IN THE DRAWINGS

REMARKS

METHODS AND SYSTEMS FOR PROCESSING MICROFLUIDIC SAMPLES
OF PARTICLE CONTAINING FLUIDS

Gene Parunak et al.
10/014,520/ 19662-026001
ANNOTATED SHEET

Fig. 1

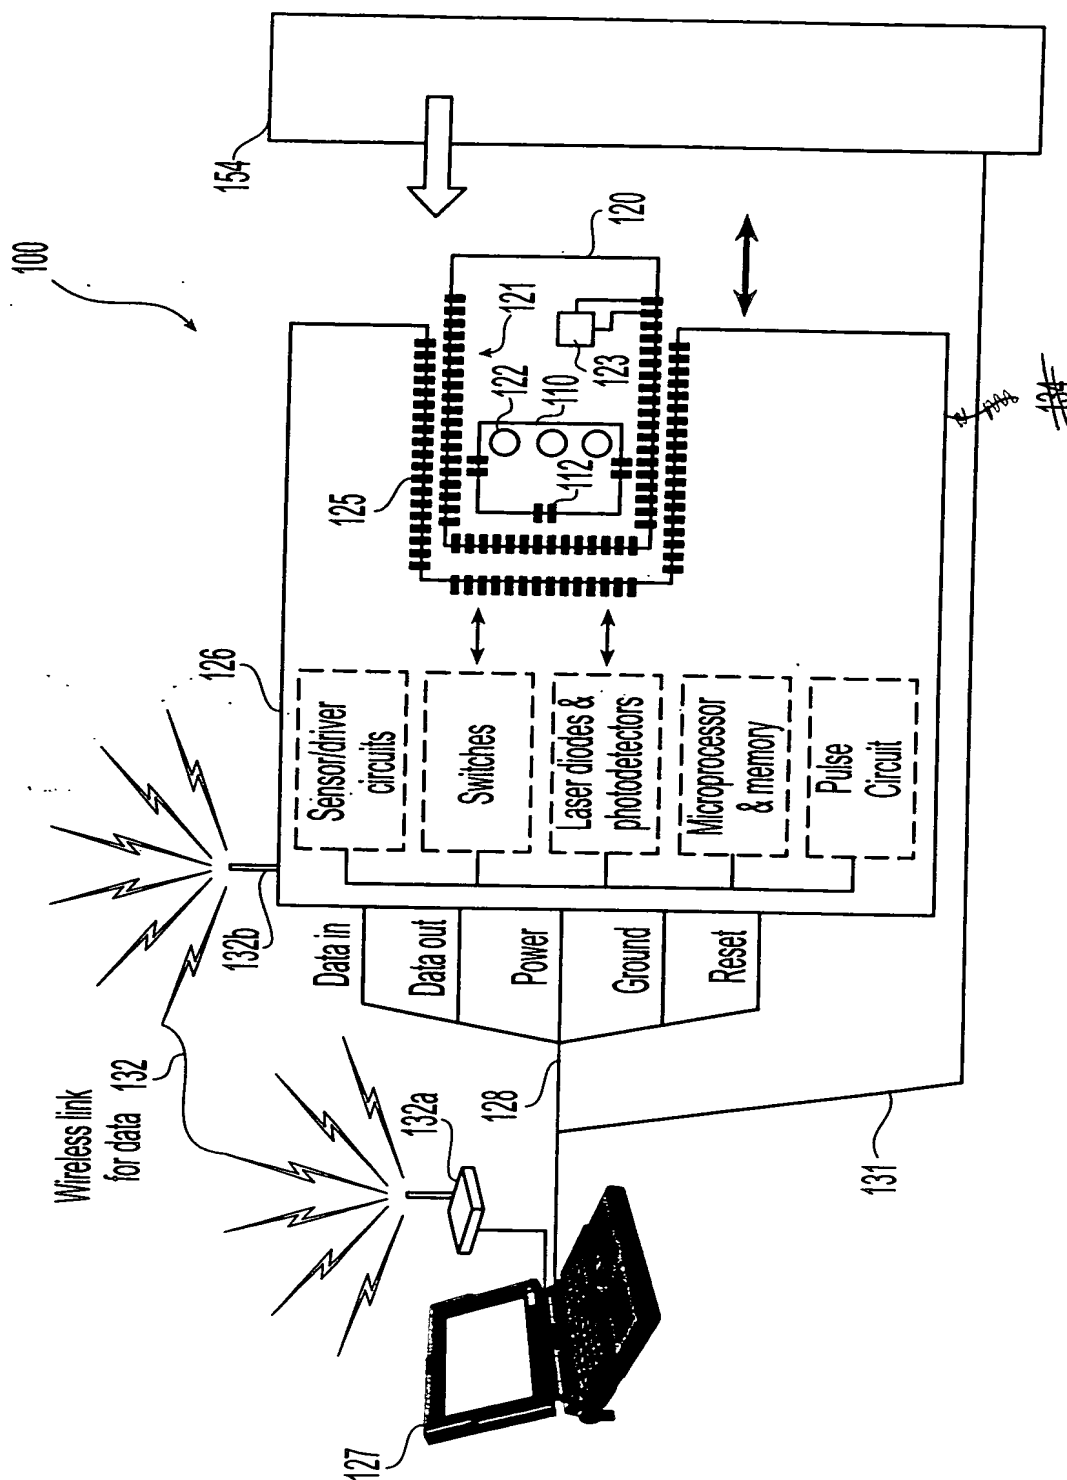
FIG. 1 is amended to delete reference numeral 134. Applicants respectfully point out that, as would be clear from the accompanying portion of the specification, the correct reference numeral 134 refers to a different element, as shown in FIG. 2.

Fig. 2

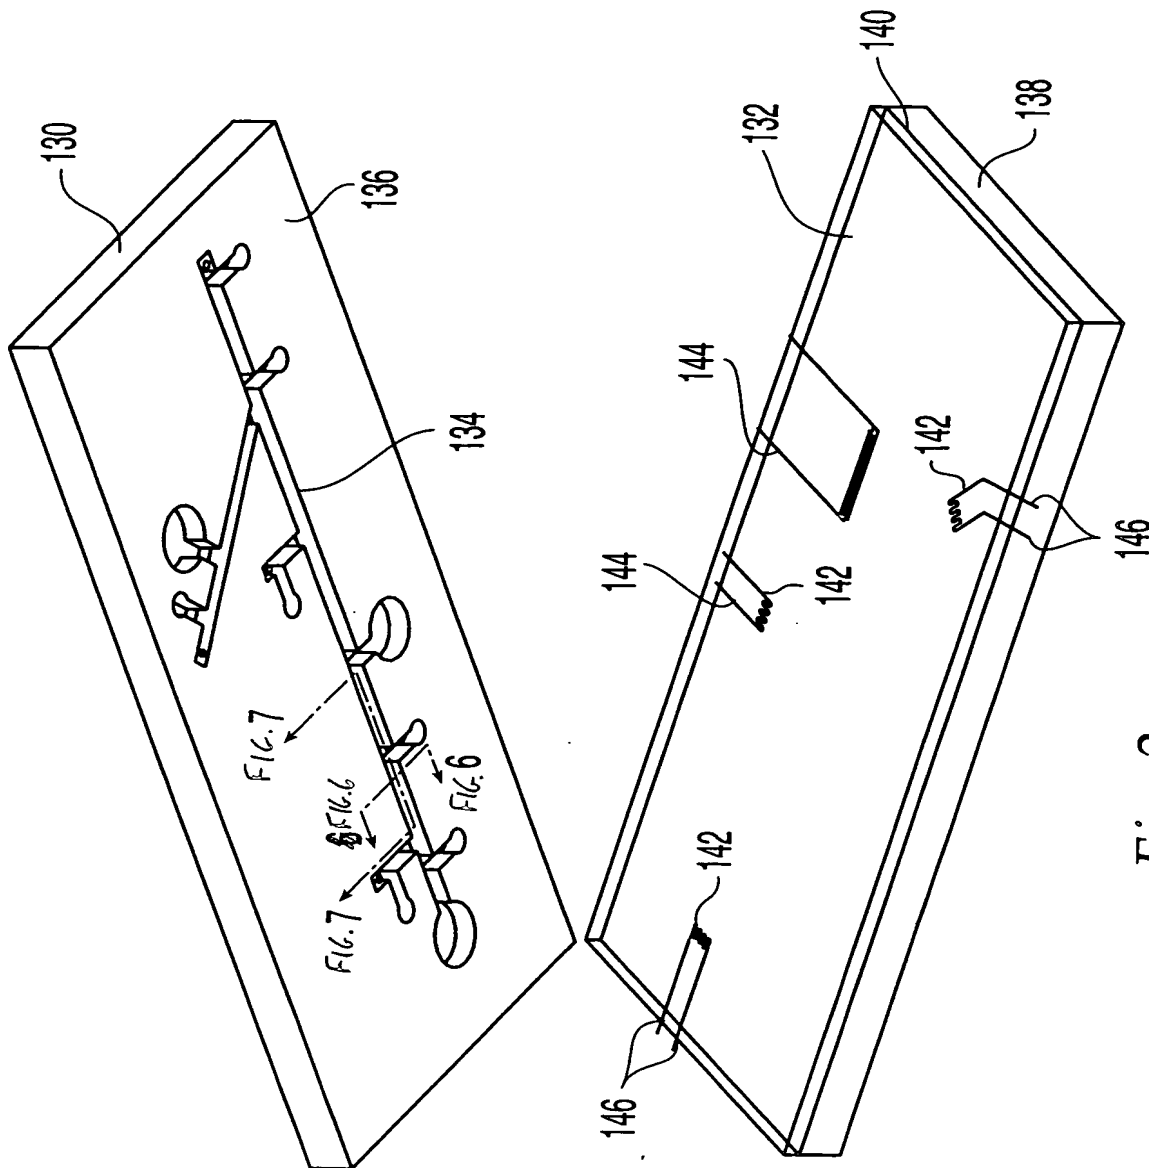
FIGs. 2, 4, 8a, and 9a are amended to insert references to corresponding figures wherein arrows are shown to indicate a cross sectional view.

Fig. 8a

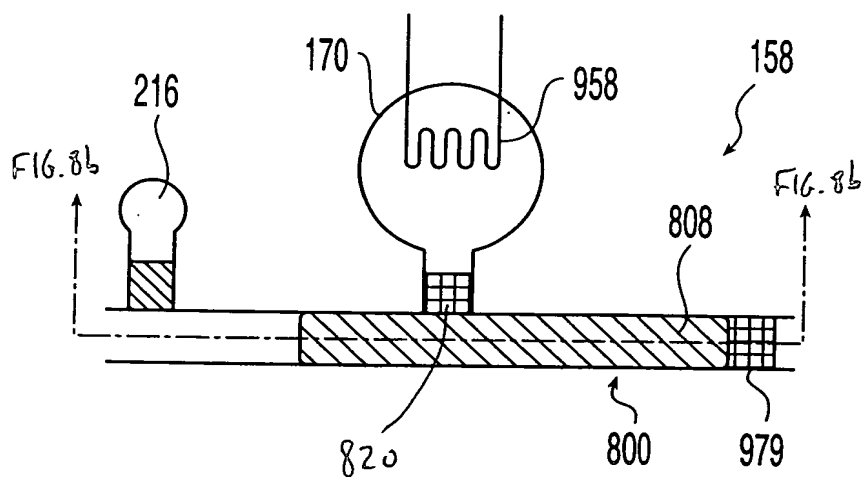
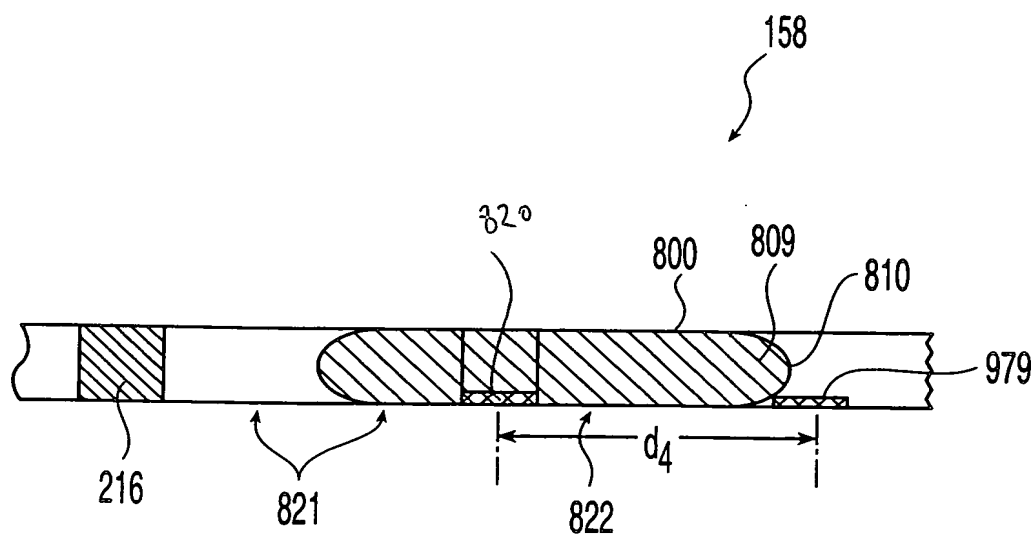
FIGs. 8a and 8b have been amended to insert reference numeral 820, as found in the accompanying description in the specification as filed.

Fig. 9a

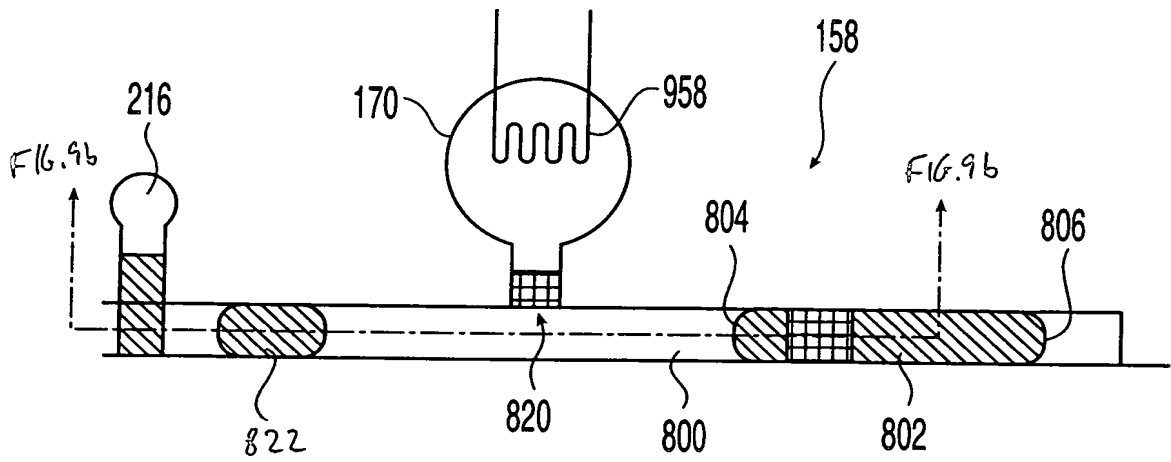
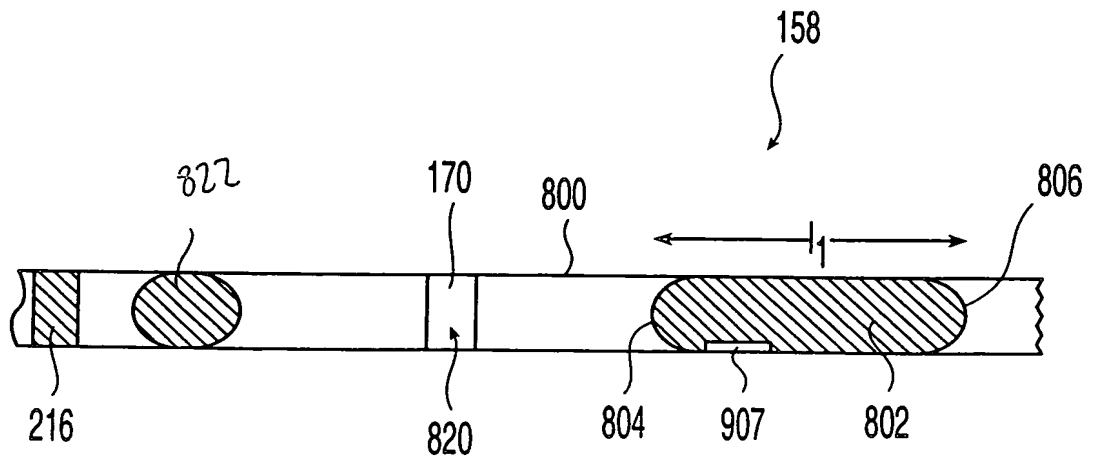
FIGs. 9a and 9b have been amended to insert reference numeral 822, as found in the accompanying description in the specification as filed.

Fig. 11a

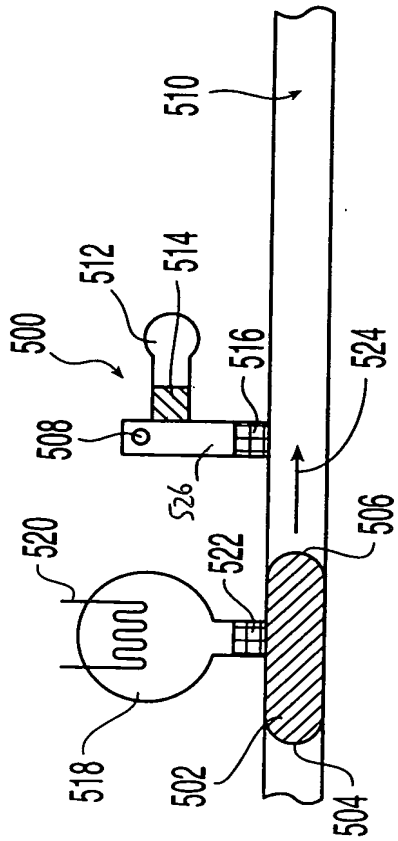
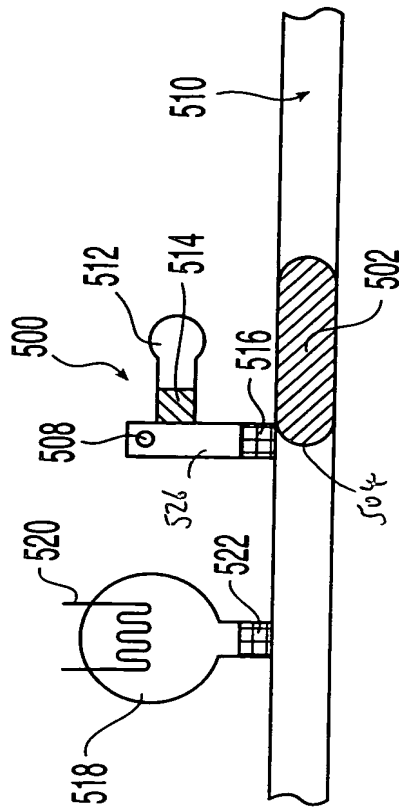
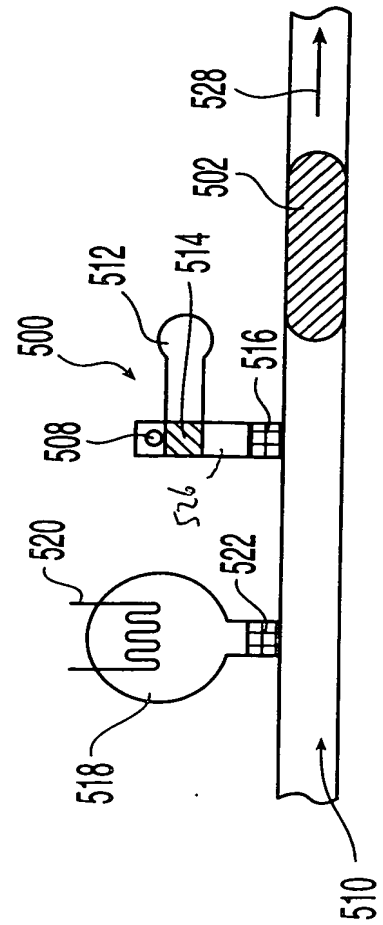
FIGs. 11a – 11c have been amended to insert reference numeral 526, and FIG. 11b has been amended to insert reference numeral 504, as found in the accompanying description in the specification as filed.

Fig. 12a

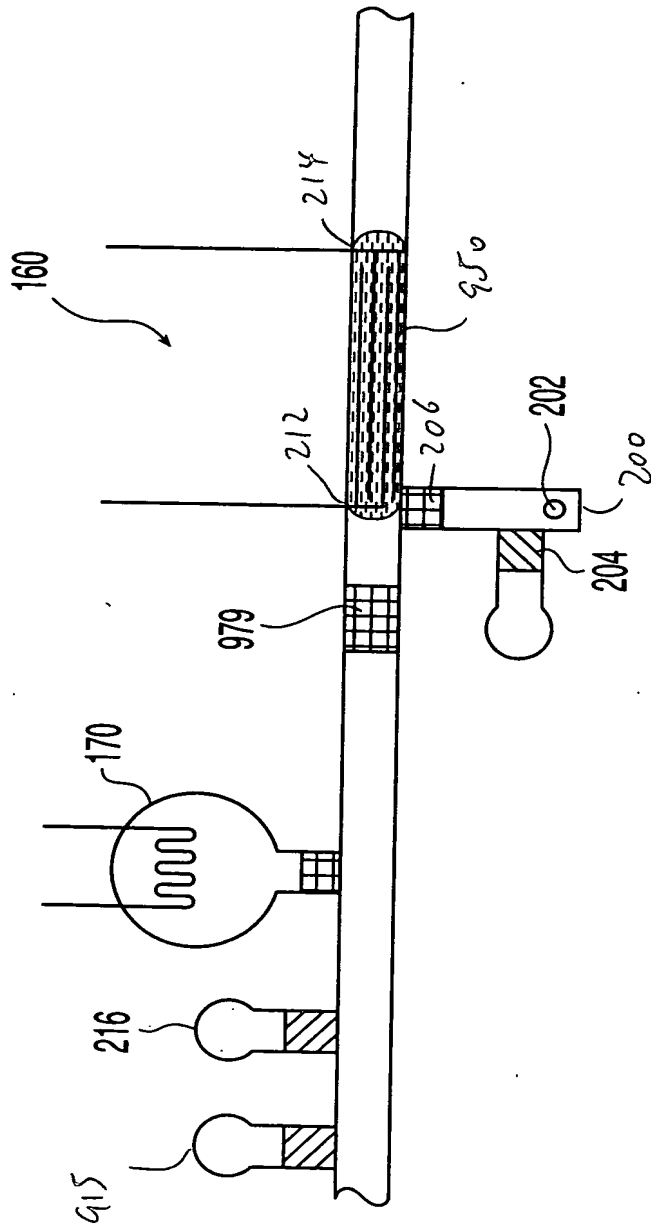
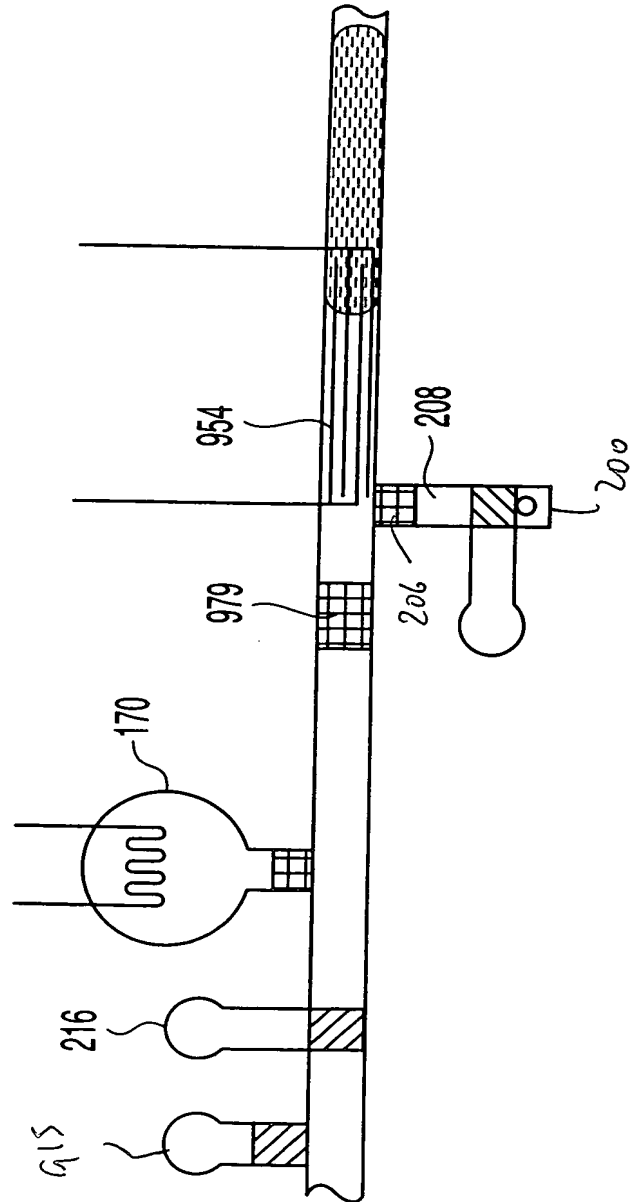
FIGs. 12a and 12b have been amended to insert various reference numerals, including 200, 206, 212, 214, 915, and 950. The positioning of such reference numerals is based on other drawings as filed and the accompanying description found in the specification as filed.

Fig. 15c

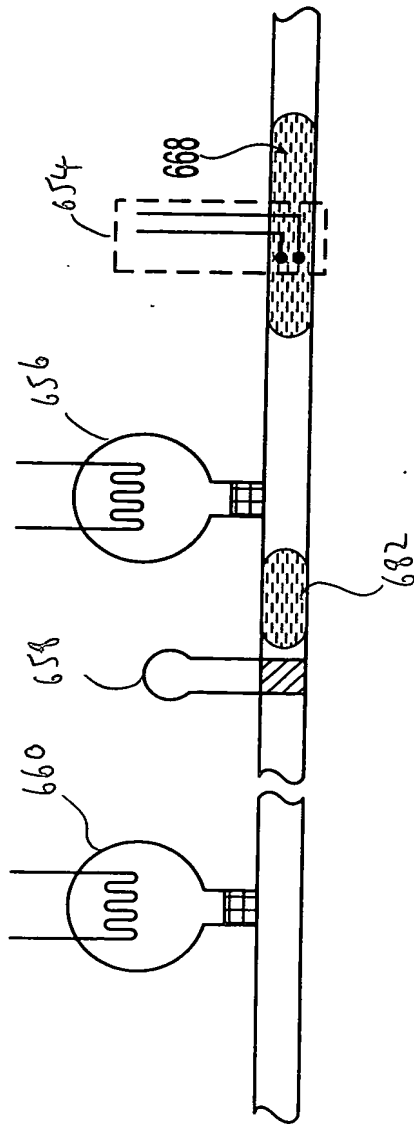
FIG. 15c has been amended to insert various reference numerals, including 654, 656, 658, 660, and 682. The positioning of such reference numerals is based on other drawings as filed (in particular FIGs. 15a and 15b) and the accompanying description found in the specification as filed.
